**ROCKFORD BOARD OF EDUCATION
INVITATION FOR BID ON SUPPLIES, MATERIALS, EQUIPMENT OR SERVICES
FOR SCHOOL DISTRICT NO. 205
ROCKFORD, ILLINOIS**

RFQ No. **16-22 Riverdahl Elementary School Additions**

RE: **ADDENDUM NO. 2**

M0100.E

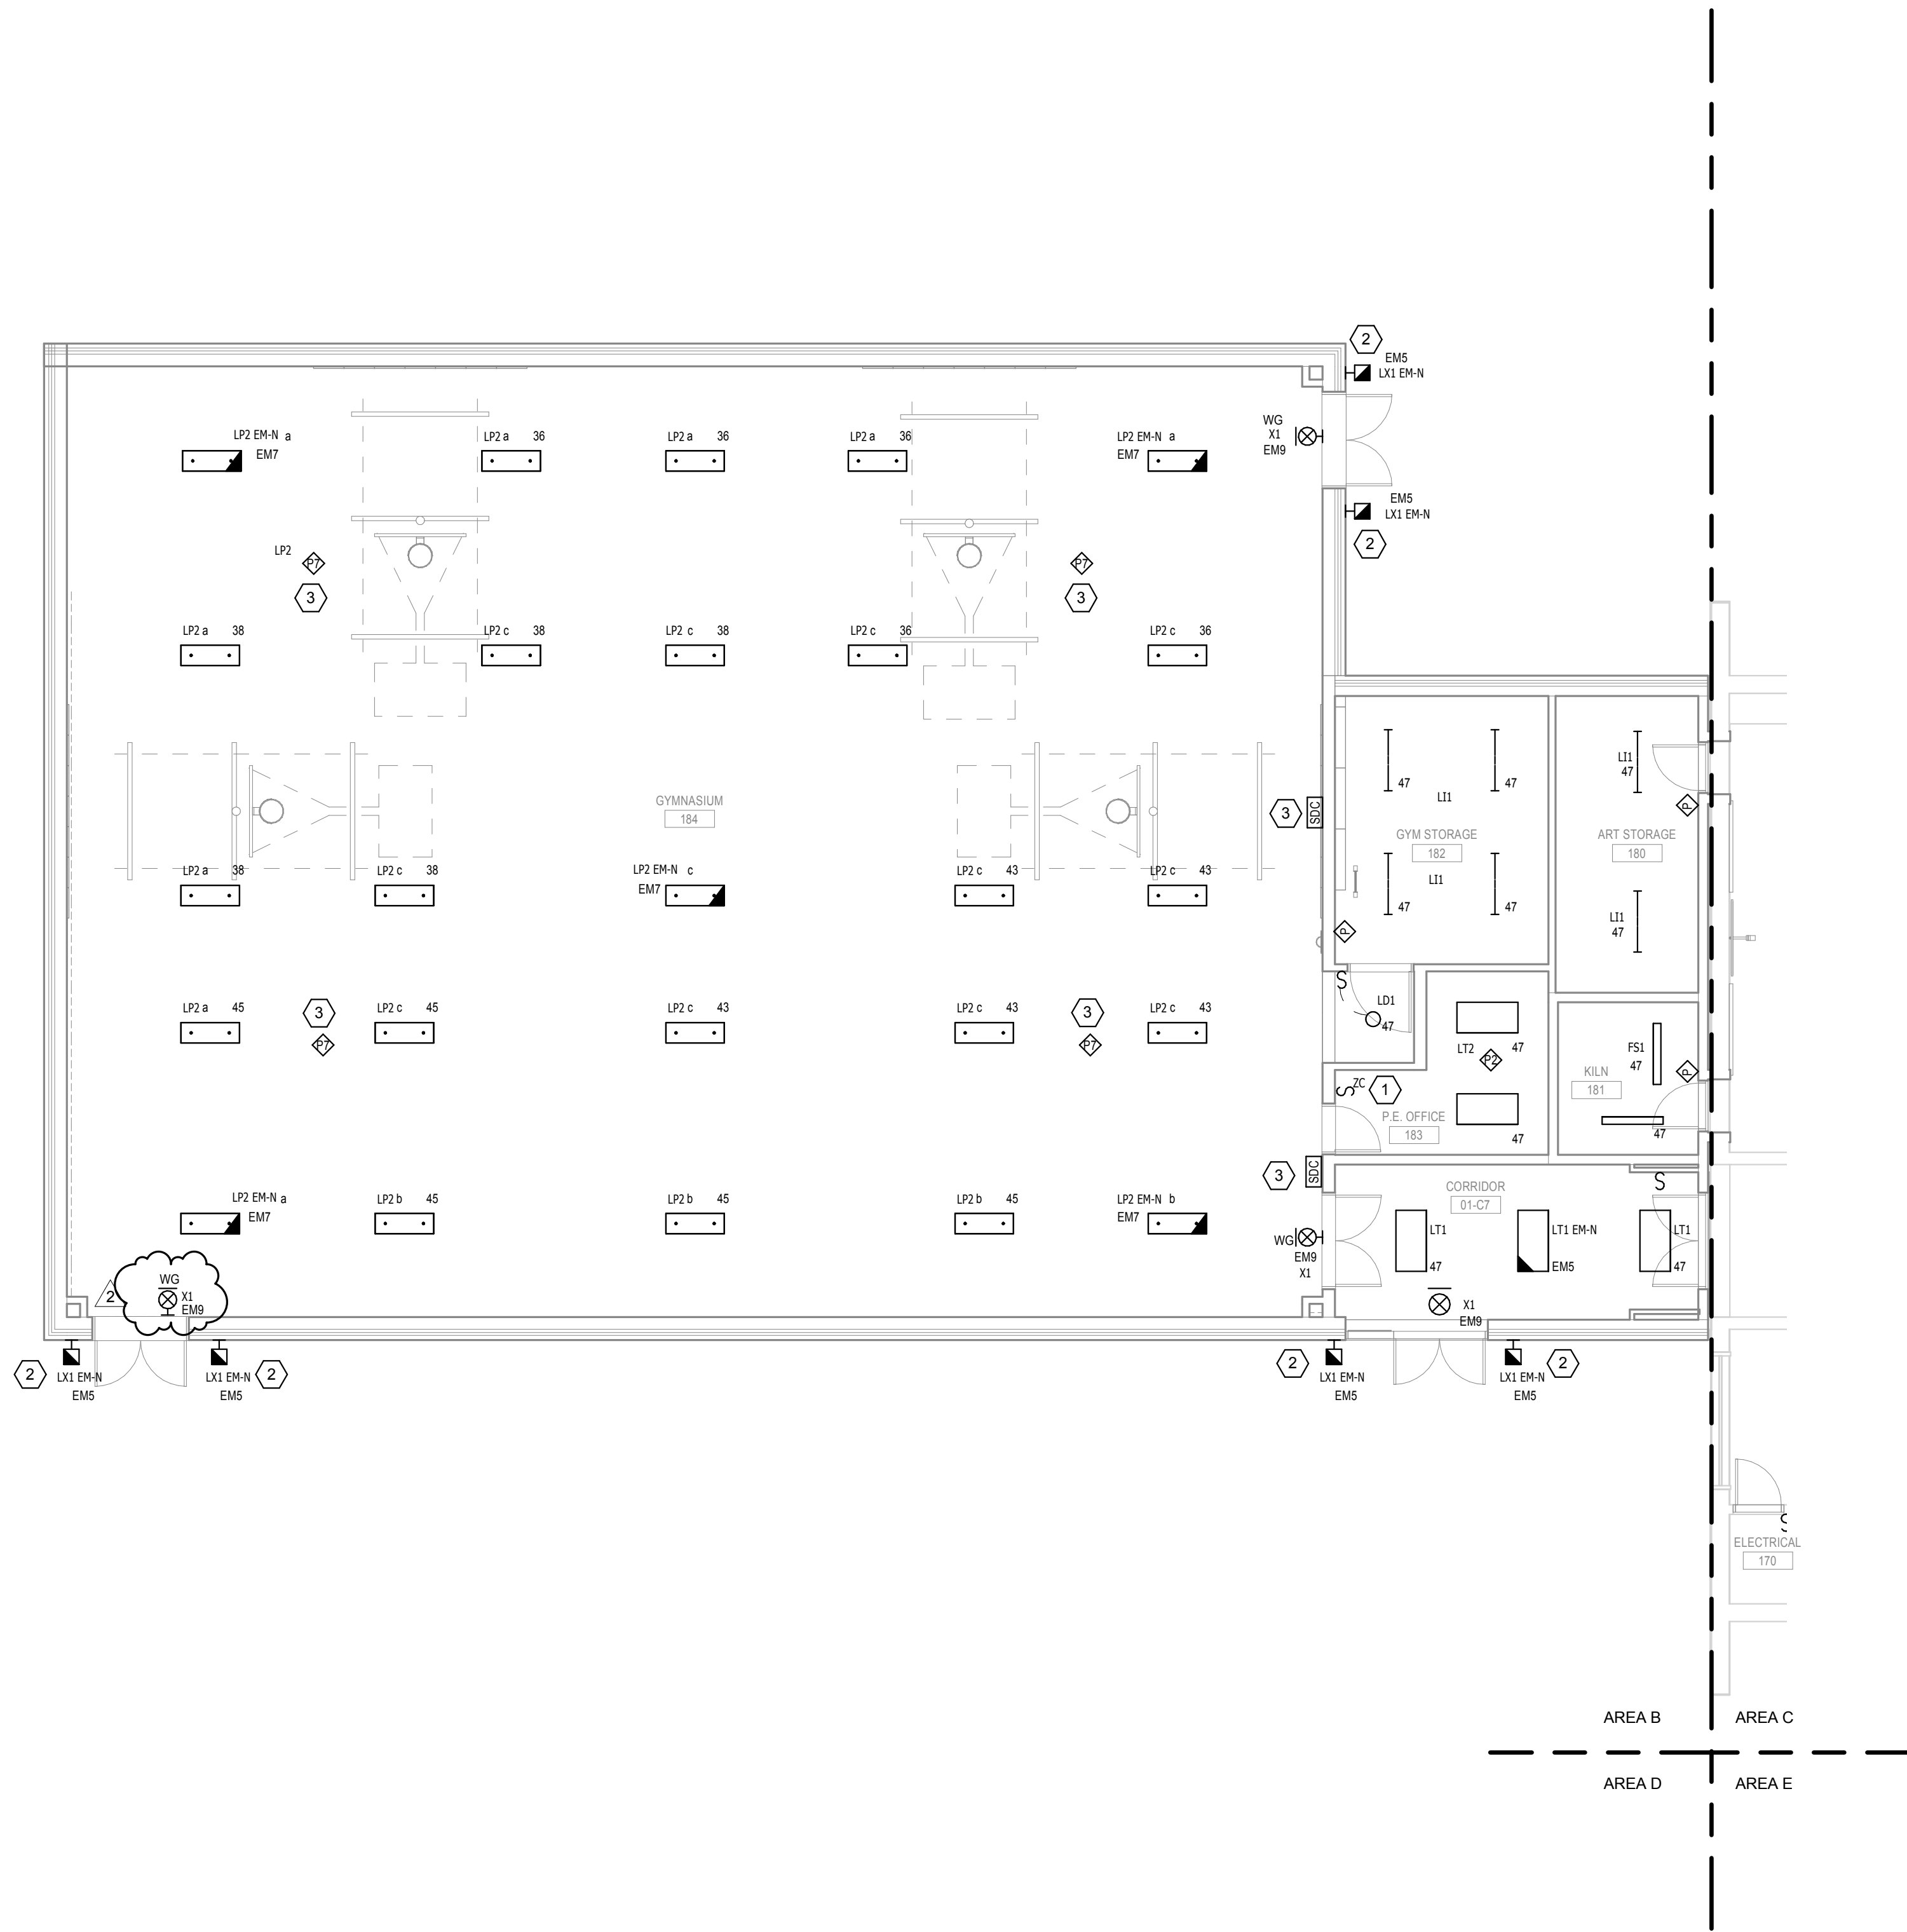
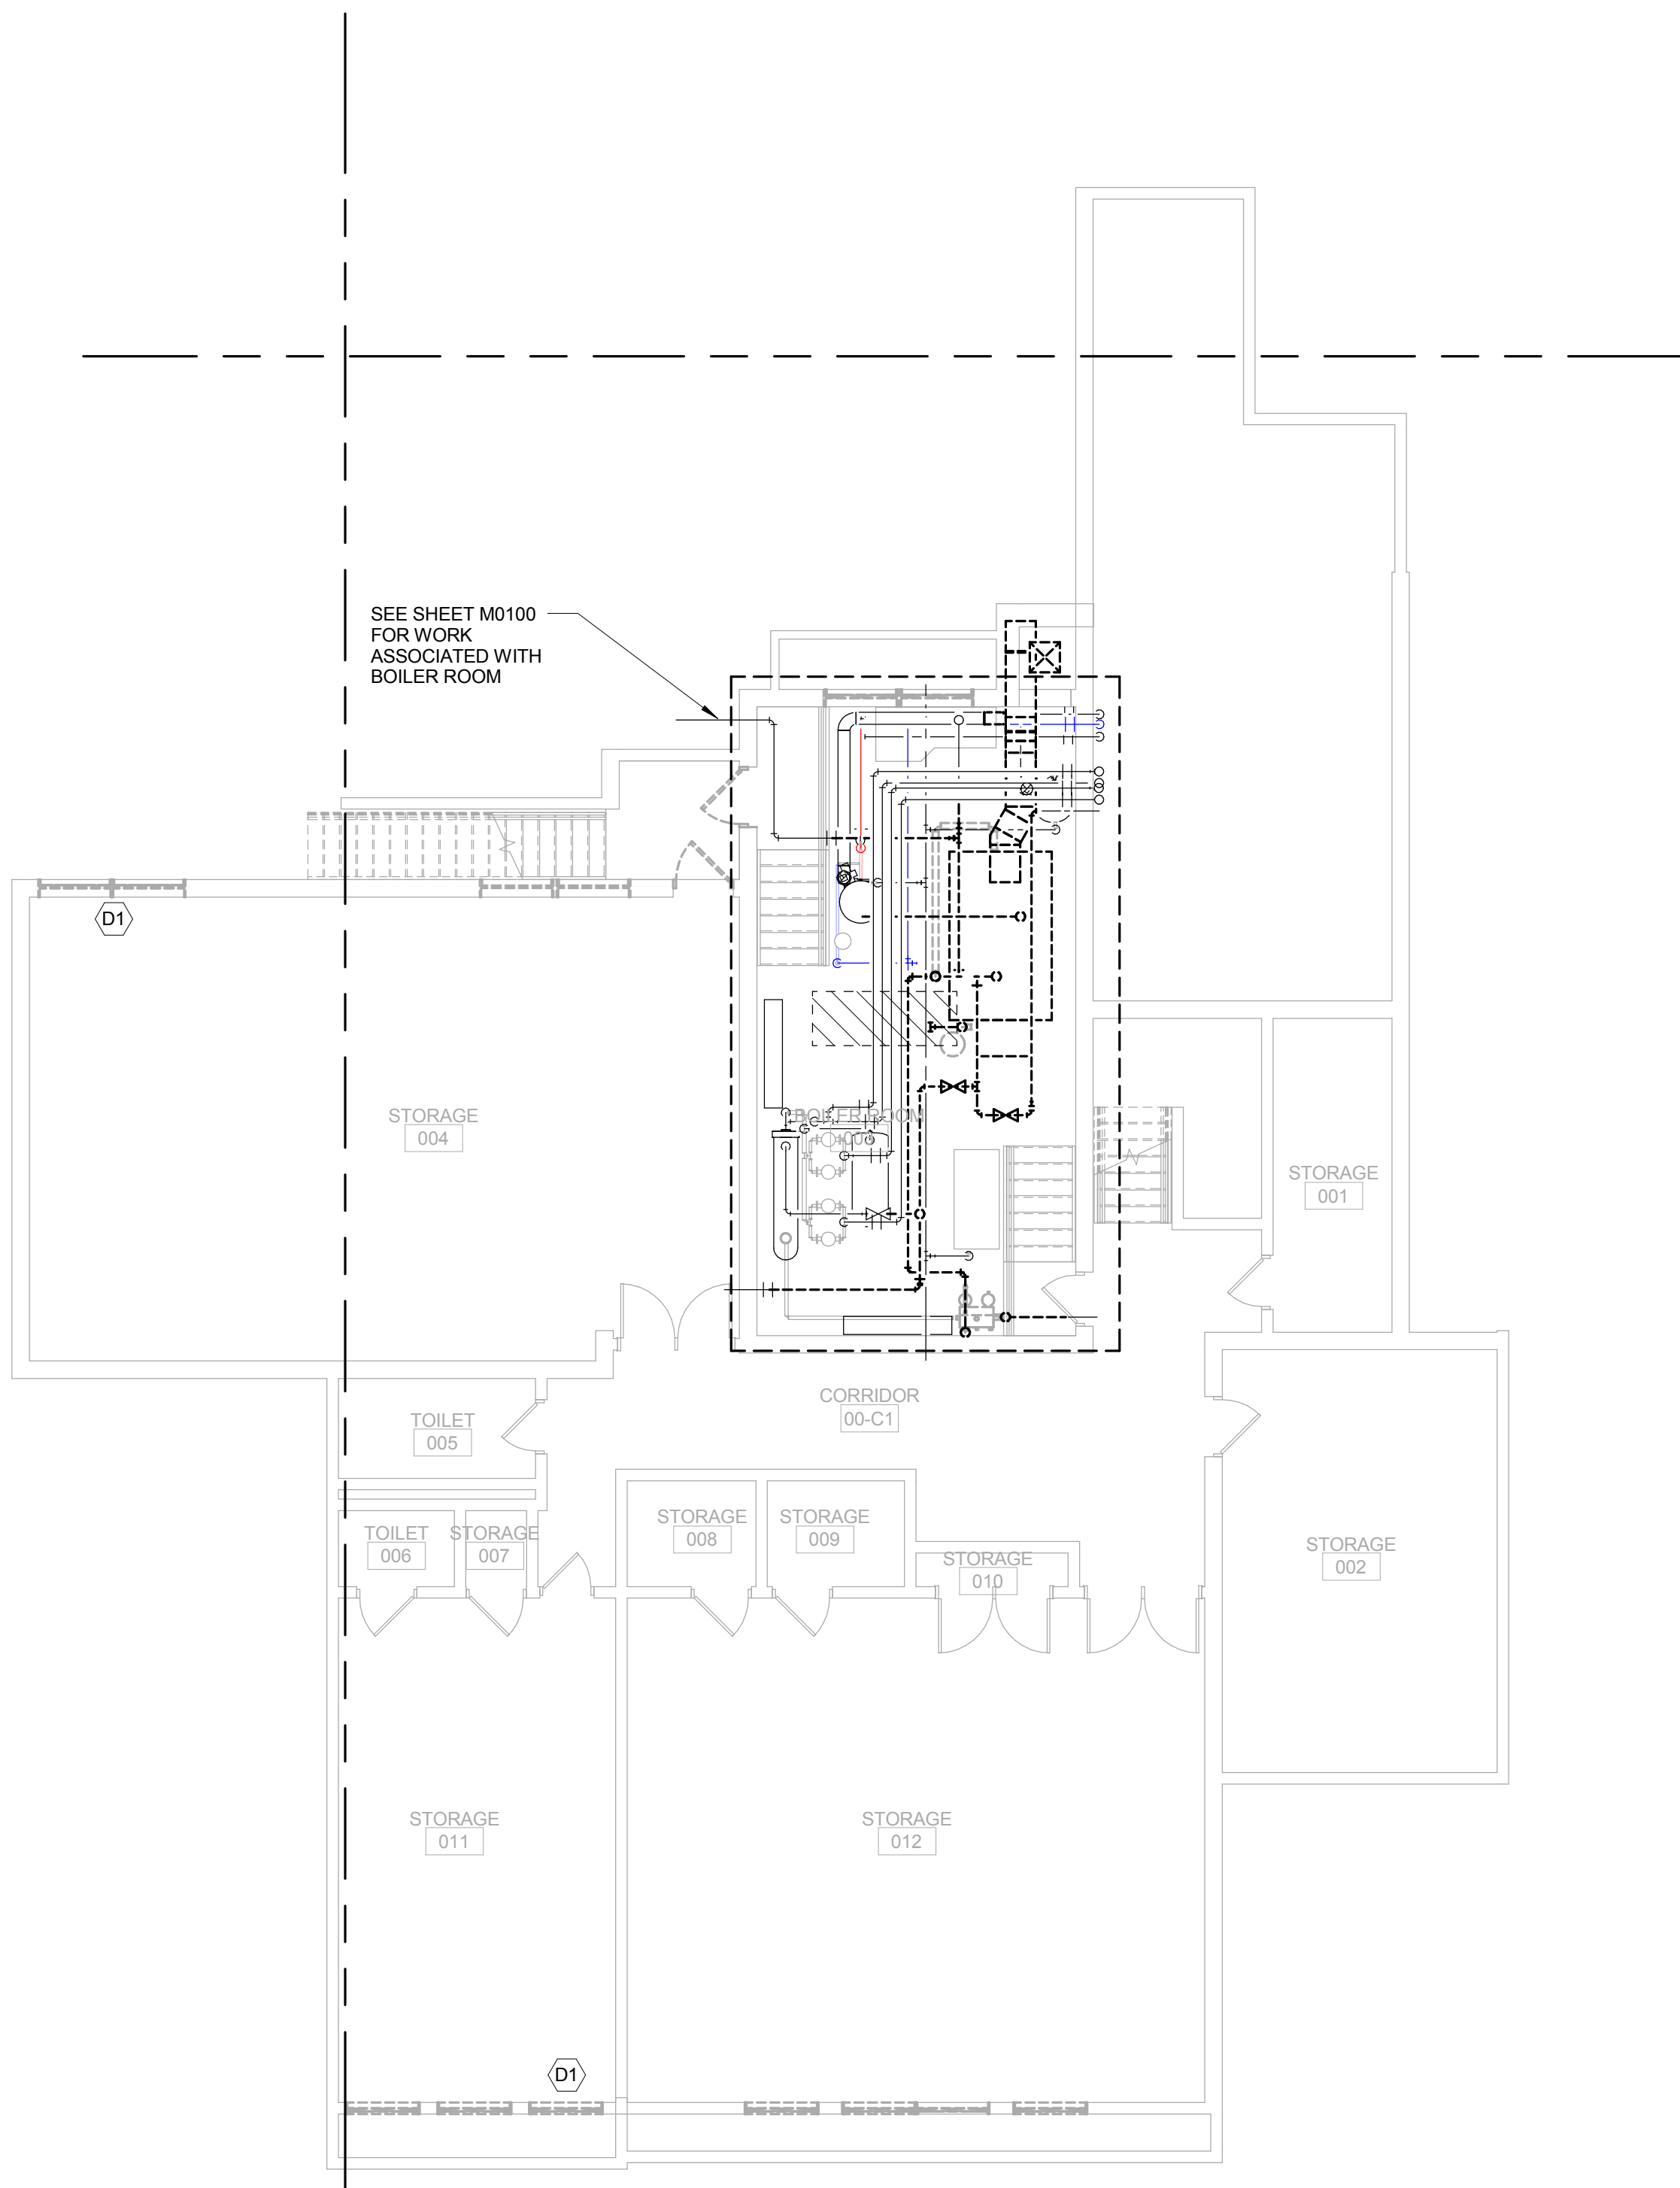
- A. Drawing M0100.E is being issued as an attachment to this Addendum. This is a new sheet to show scope of work if Alternate 2B is taken.
23. E0101.B – LEVEL 01 LIGHTING PLAN – AREA B
